Date: July 19, 2011

From: David A. Bruce (Nuclear Chemical Process Engineer -- WTP Project)

Subject: Defense Nuclear Facilities Safety Board Recommendation Concerning the WTP Project Nuclear Safety & Quality Culture

From: Bruce, David (WGI)
Sent: Sunday, November 25, 2007 8:11 PM
To: Brouns, Richard; Duncan, Garth M; Musick, Chris A; Olson, John W; Eager, Kevin
Cc: Bruce, David (WGI)
Subject: CNP Evaporator Liquid Level and Spgr Instrument Line Design Deficiencies

CNP Evap Inst.
Lines Case 1 11...

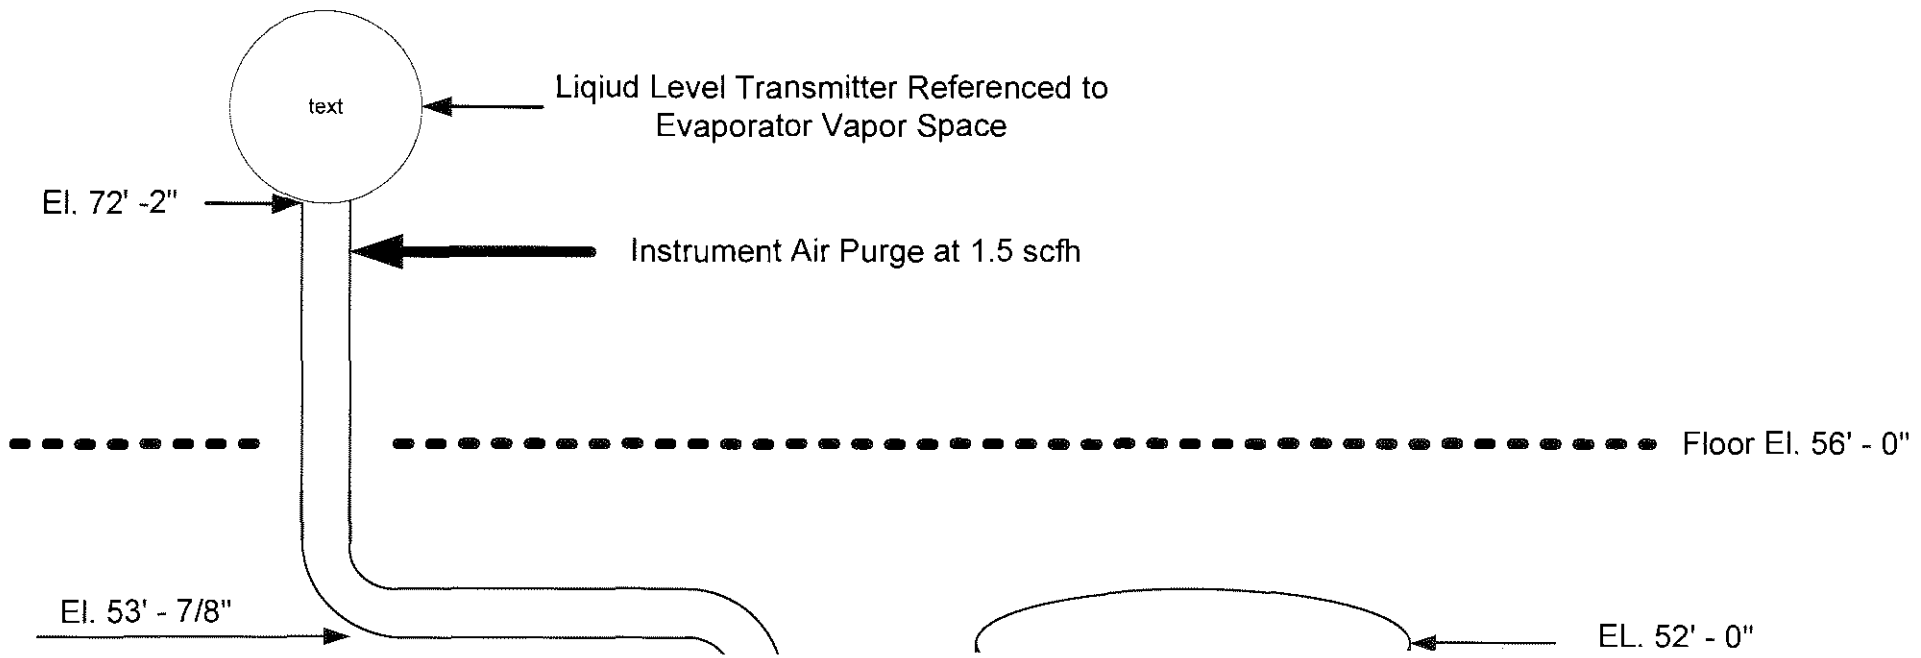
CASE #1 — CNP Evaporator operating at 80 mm Hg Pressure

1. Instrument line and liquid level dip tube filled with air and air bubbling into evaporator solution at 1.5 scfh.
2. Air pressure in instrument = liquid head from liquid column from liquid surface to end of dip tube + the pressure on the liquid surface. Solution height above end of dip tube = 63". For a solution of 1.10 spgr, the solution head = $(1.1)(63) = 69.3$ in. water pressure in the instrument line.

3. The volume of the instrument line can be found from the pipe dimensions. The instrument line is made up of 2 feet of 1" sch 160 Hasteloy pipe (0.25" wall thickness) and 118 feet of ½" sch 40 316L SST pipe (0.109" wall thickness). Total instrument line volume = 443 cubic inches.

$n = PV/RT$ $n = (209.44)(7.26)/(62.3637)(305.37) = 0.07985$ g-moles of air contained in the instrument line when the evaporator is operating at a pressure of 80 mm Hg with a liquid spgr of 1.10. (Note that there will be no appreciable change in the number of g-moles of air in the instrument line when the vacuum is released and the evaporator is returned to atmospheric pressure. When this occurs, evaporator liquid is forced up into the instrument line so quickly that the 1.5 scfh air purge does not have time to add any appreciable quantity of air to the instrument line before the liquid has filled the instrument pipe to maximum level) The number of g-moles of air calculated in Case #1 is the same as the g-moles of air used in the Case #2 calculations.

CNP Evap Inst.
Lines Case 2 11...

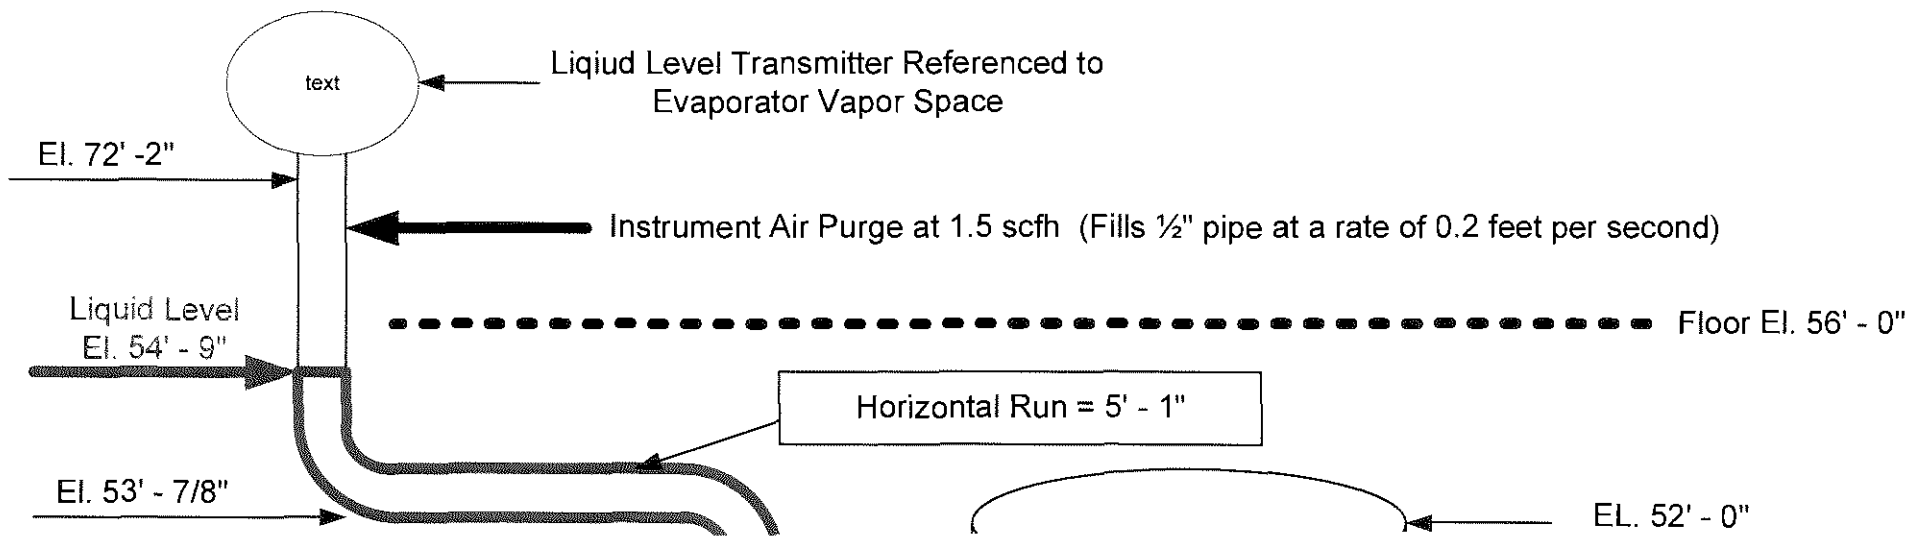
CASE #2 — CNP Evaporator returned to atmospheric pressure for empty out --- Evaporator pressure = 760 mm Hg

1. Instrument line and liquid level dip tube has evaporator solution pushed up into line by pressure in evaporator.
2. Air pressure in instrument is unknown and will be calculated.

The values of P & V are determined by iteration of the PV product where a height of liquid in the instrument line is assumed. Values of P & V are determined from the piping diagrams as follows: Because the weight of the liquid in the evaporator will fill up the instrument line up to the level in the evaporator, the height "h" of solution in the instrument line above the evaporator liquid level = the iteration height value minus the evaporator liquid level elevation. Evaporator liquid level El. = 36' - 9". The air pressure above the liquid level in the instrument line = 760 mm Hg - (Rho)(h) mm Hg. The air volume V is determined from the number of feet of piping that is above the chosen elevation on the piping drawings. When this iterated product of $PV = 1520.67$ the problem is solved and the last elevation chosen is how high the solution will rise in the instrument line. (By iteration, the PV product is 1774 at a liquid elevation of 54' - 6" in the instrument line. The PV product is 1358 at a liquid elevation of 54' - 9" in the instrument line. The actual liquid elevation will be between 54' - 6" and 54' - 9", not allowing for the kinetic energy of the liquid surge. The liquid will rise up in the instrument line 18 feet above the evaporator liquid level to an elevation of approximately 54' - 9")

Design Change Option #1

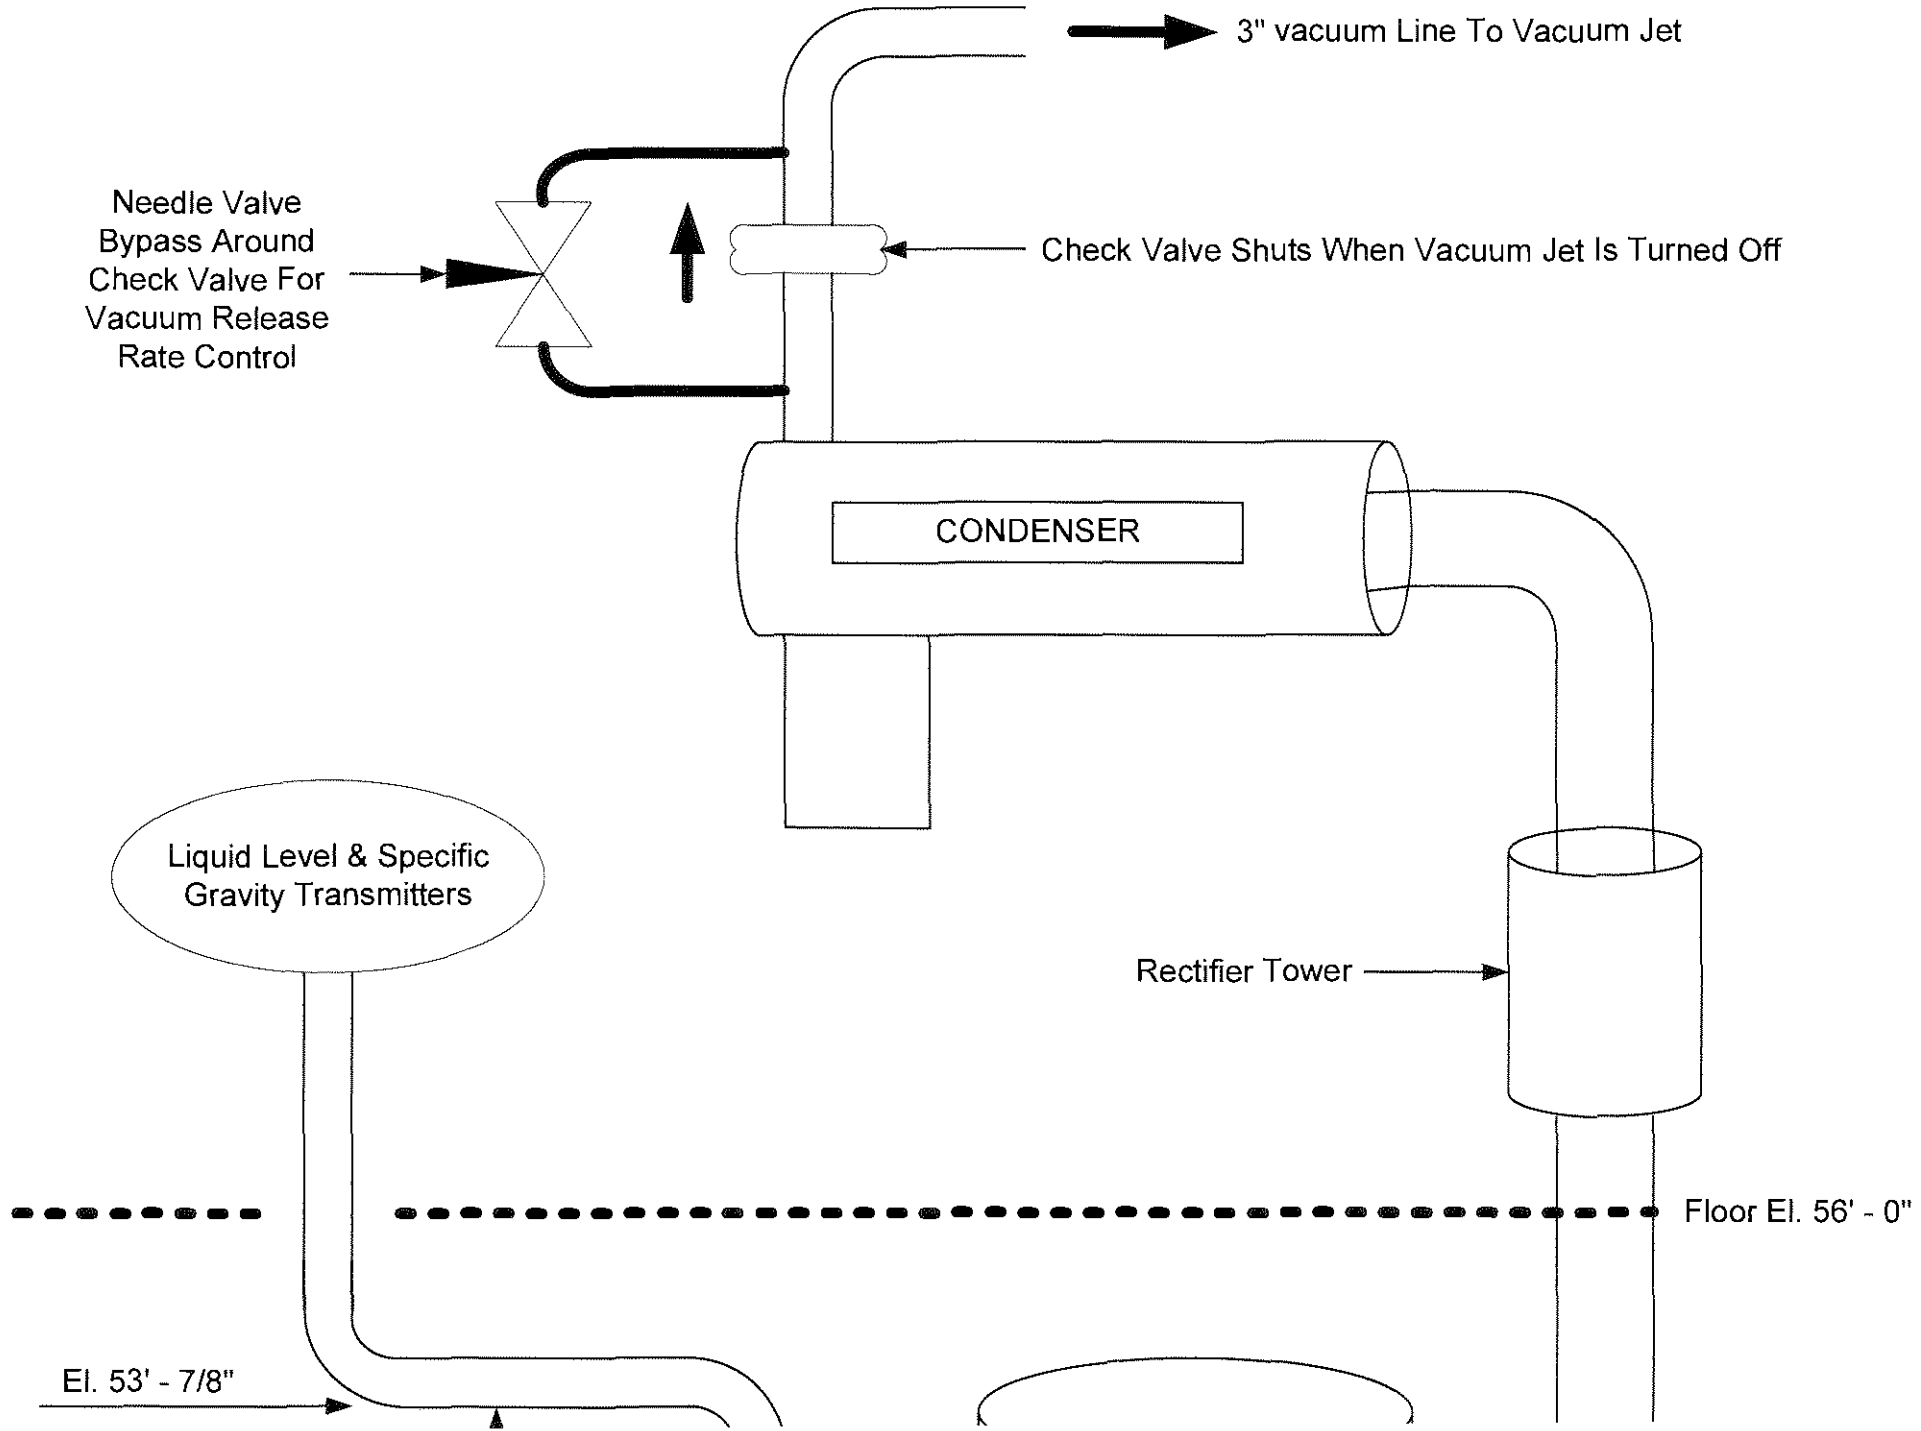
Evaporator instrument line vertical design to bring horizontal runs up above maximum solution level, instrument line pipe material same as dip tubes, and vent line check valve to control evaporator vacuum release rate .
(This is the minimum design change necessary for CNP)

Design Change Option #2

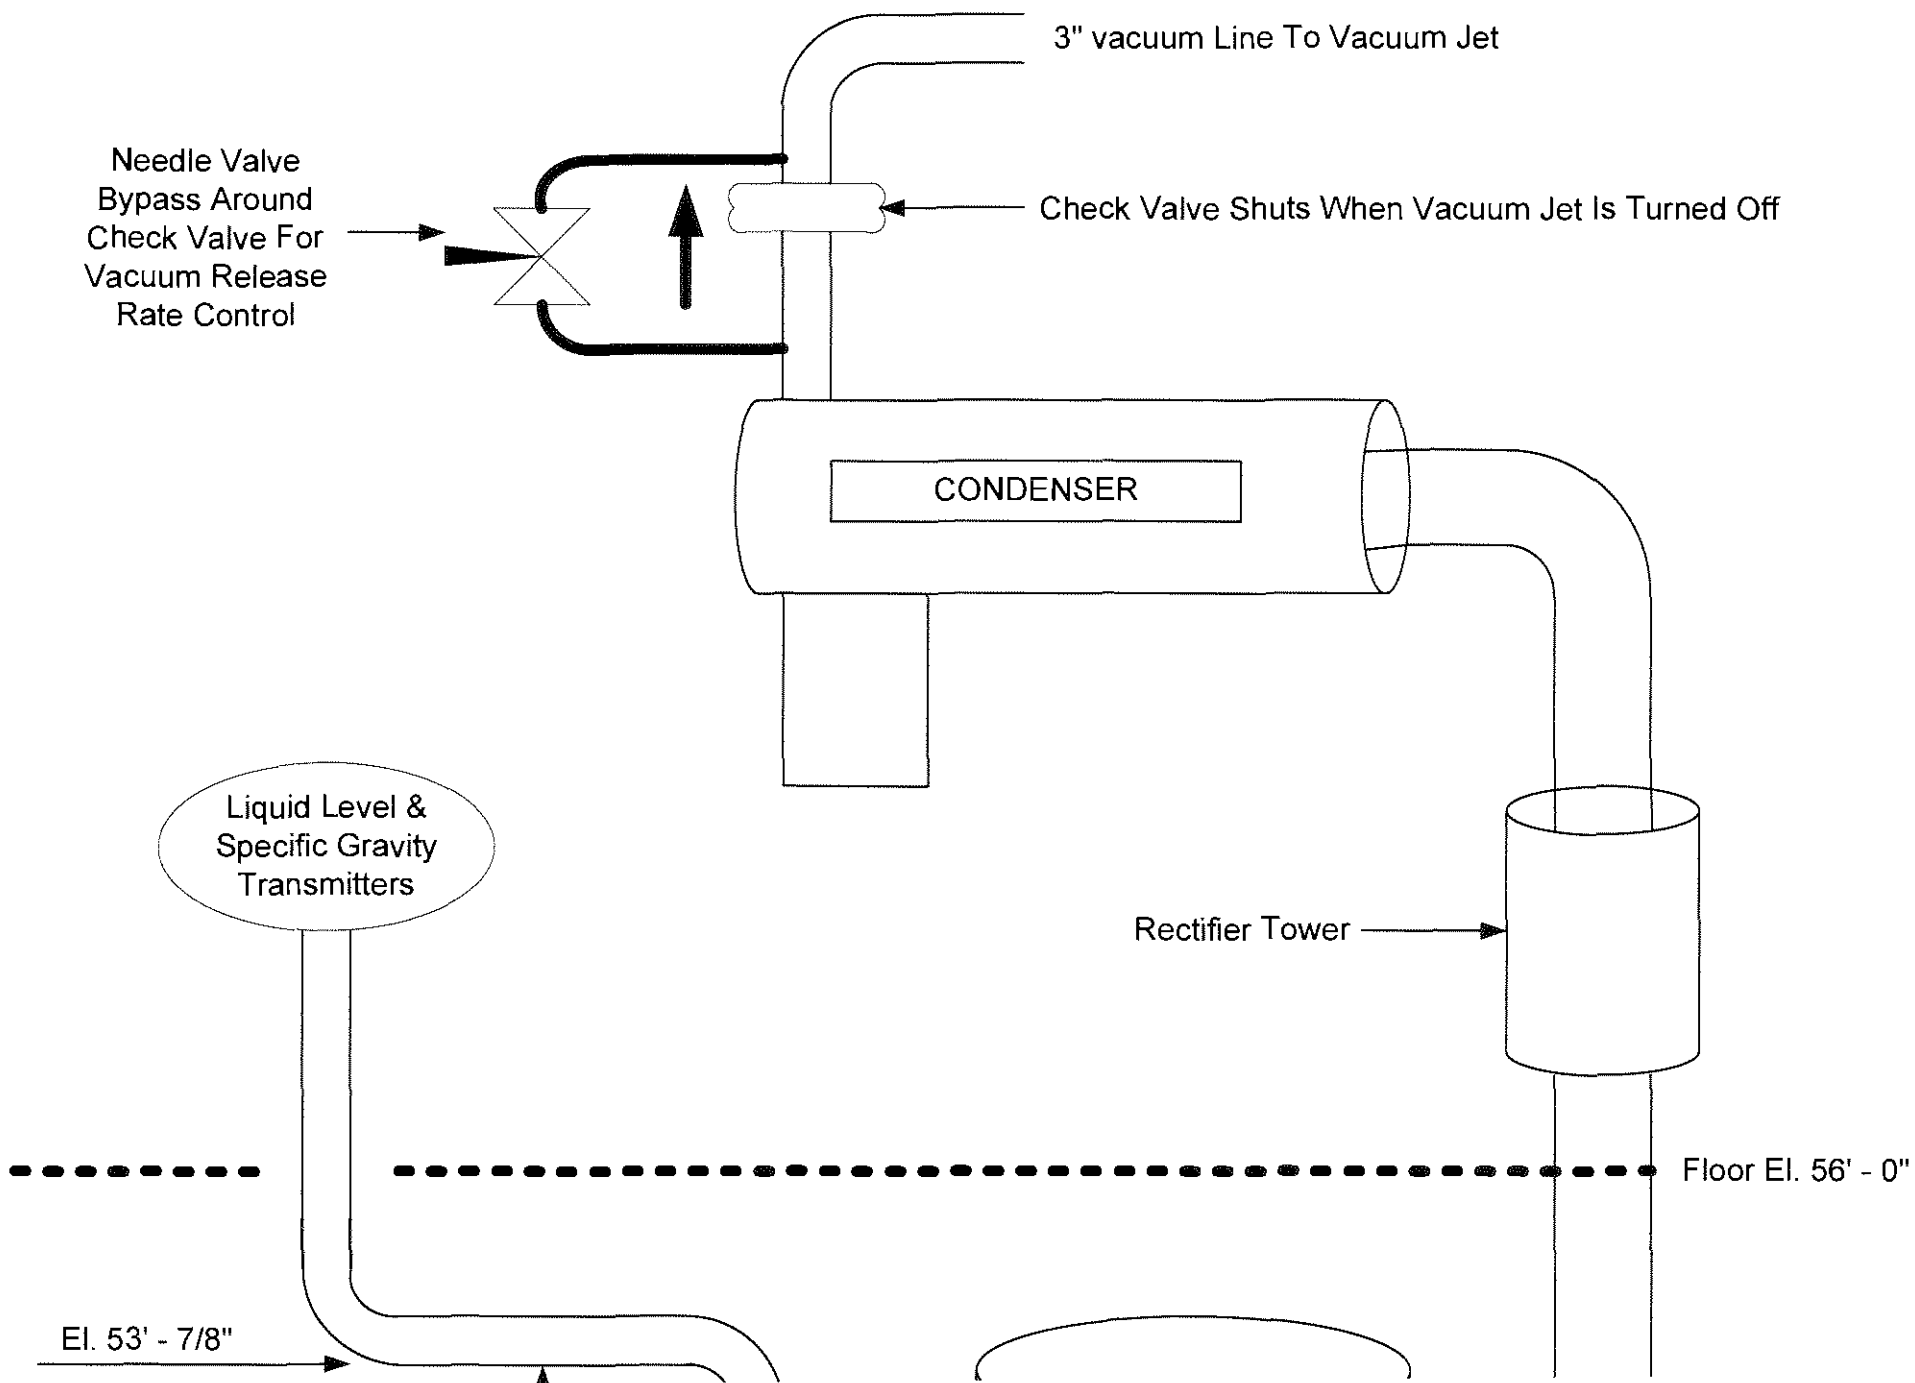
Evaporator instrument line vertical design to bring horizontal runs up above maximum solution level, Instrument line pipe material same as dip tubes, Vent line check valve to control evaporator vacuum release rate, and Dip tube changed from horizontal to vertical design to minimize plugging of dip tube.
